Prop. Block Plan.

Project:-
Proposed
with 'L'
Rear &
Window

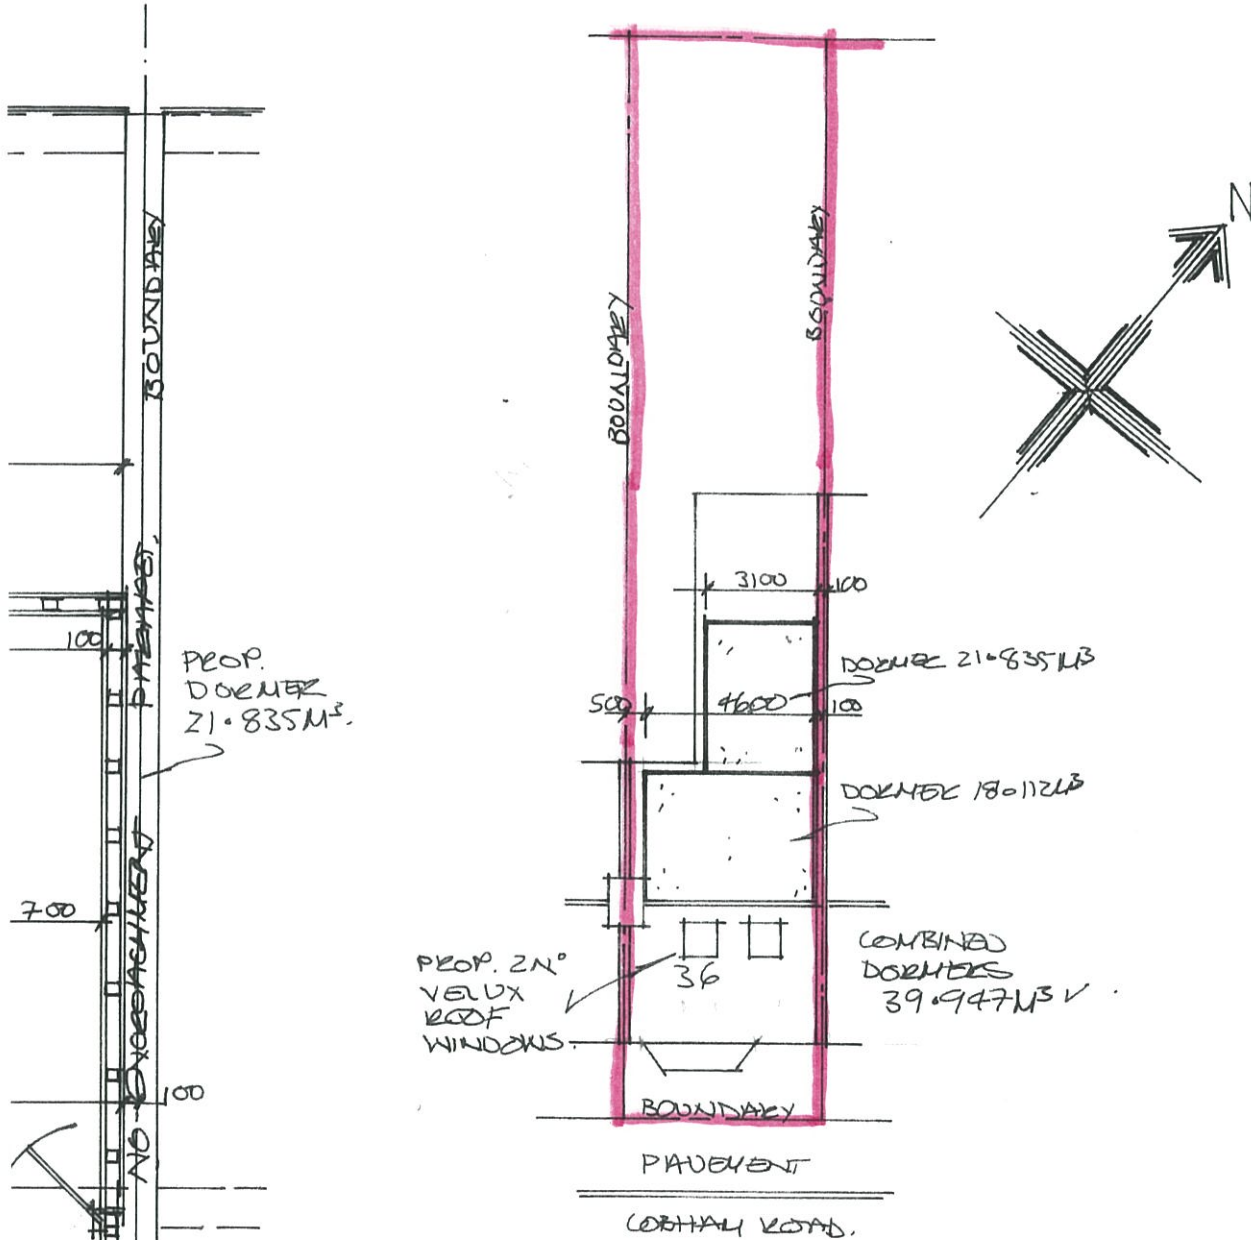
$$\textcircled{1} + \textcircled{2} = 18.012 + 21.835 = 39.947 \text{M}^3 \checkmark$$

MID TERRACE PROPERTY PROPOSED DORMERS
NOT TO EXCEED 40M³. 39.947M³ THEREFORE
COMPLIES, LDCP TO BE ISSUED. ✓
